#### SIB 11 02 22 RECALL 22V-752: REPLACE CLUTCH COVER SCREWS

2022-11-10

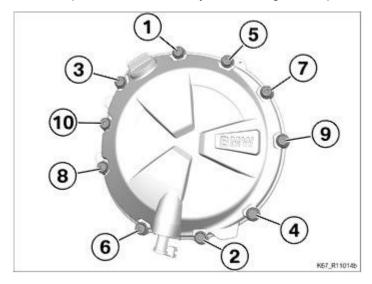
The clutch cover screws were produced with too much protective coating which can cause the screws to back out causing oil to oil leak onto the catalytic converter.

Replace all 10 clutch cover screws using repair instruction "11 14 085".

- Mark all the screws currently installed.
- Check for oil leaks or traces of oil visible between the clutch cover and crankcase.
  1. If there is a leak the repair including a gasket exchange is required.
- Replace the screws 2 by 2, following the sequence as shown below.

- Remove screws 1 and 2.
- Clean screw points (screw head contact and especially thread).
  - 1. Treat bore / thread with suitable cleaning spray.
  - 2. Clean head contact on the clutch cover with rag.
  - 3. Blow clean bore / thread with air gun.
- Install new screws and tighten in the correct sequence as shown with 3Nm + 90°.
- Repeat steps for screw pairs 3/4; 5/6; 7/8; 9/10.
